System Impact Assessment Report

**Talbot
Wind Generation Station (WGS)**

Final Report

CAA ID 2008-335

Figure 1: Setting for Grid Under-frequency Trip Protection

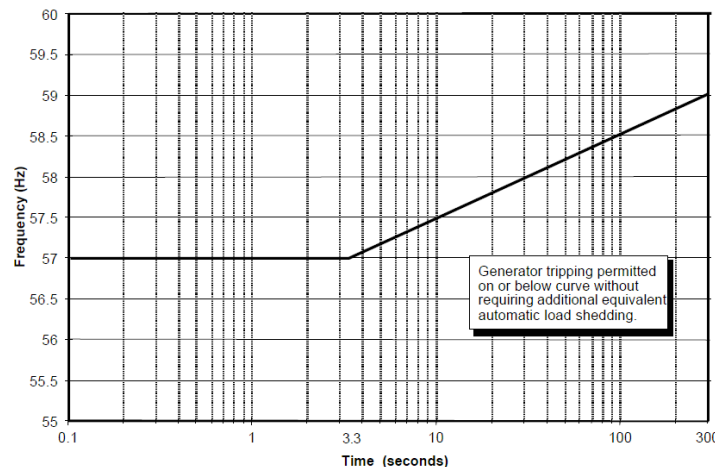
- (8) The generators should not trip for frequency variations that are above the curve in Figure 1.
- (9) The applicant is responsible for providing real-time telemetering of following variables to the IESO.

Figure 9: Proposed arrangement of the new SS

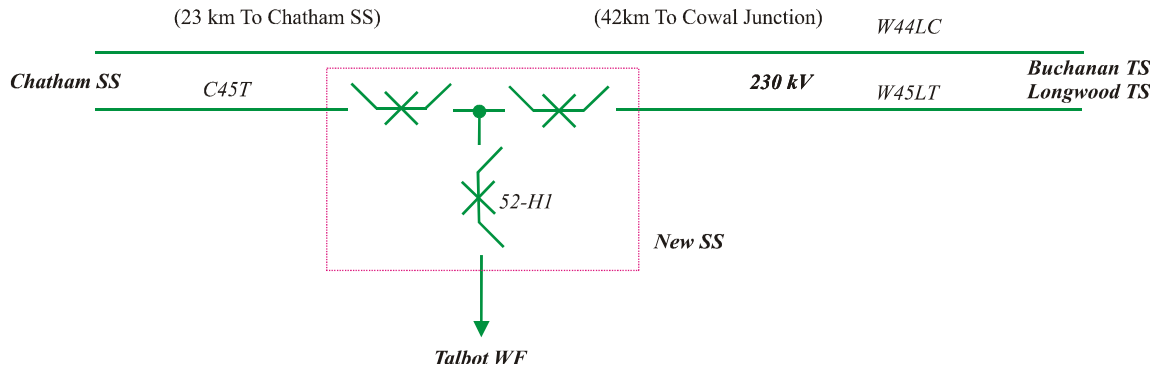
To avoid the possibility of zone 2 time protection operation for stable power swings the PIA study recommended to sectionalize circuit W45LC and build a new Switching Station at the tap to Talbot wind farm. The proposed arrangement of the new switching station is shown in Figure 9. It is recommended to replace the existing directional comparison scheme with line differential protection for the sections of circuit W45LC between new SS, Buchanan and Longwood (W45LT), new SS and Chatham SS (C45T).

The IESO concluded that the proposed arrangement in the PIA is a practical and acceptable approach for solving protection coordination issues and the security of Talbot WF will be improved by connecting to the system when either new section of C45T or W45LT is out of service. Therefore, this SIA study is carried out based on the proposed arrangement and the impact of the proposed arrangement and protection settings on the reliability of the IESO-controlled grid is examined.

- (1) The connection arrangement must be changed to reflect the findings of the Protection Impact Assessment (PIA), i.e., in-line breakers on W45LC should be installed as requested.

Figure 10: Terminal Voltage of Wind Generator During 3-phase fault at Talbot SS

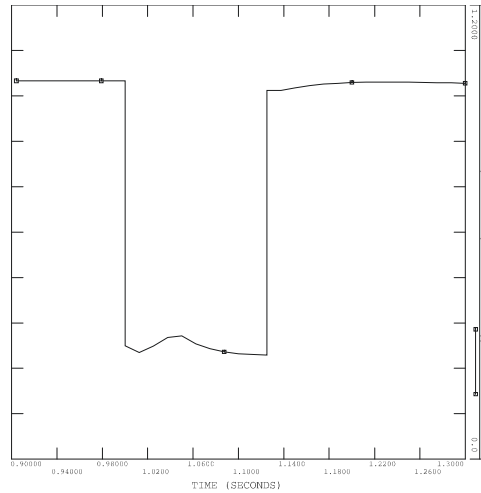
In order to examine the need for low voltage ride through (LVRT) capability, the three phase fault on W45LT at Talbot SS with normal clearing time plus 50 ms for receipt of blocking signal were simulated. These particular contingencies are electrically much closer to the new generation facility than other contingencies. Thus, they could potentially have a greater impact on the terminal voltage of the facility. The variation of the terminal voltage of the new generation facility is plotted in Figure 10 below. It can be seen that the duration during which the generator terminal voltage drops below 0.5 pu is about 0.13 sec. Therefore, fault ride through capabilities of the wind turbines is adequate.

The LVRT capability must be demonstrated during commissioning by monitoring several variables under a set of IESO specified field tests and the result should be verifiable using the PSS/E model.
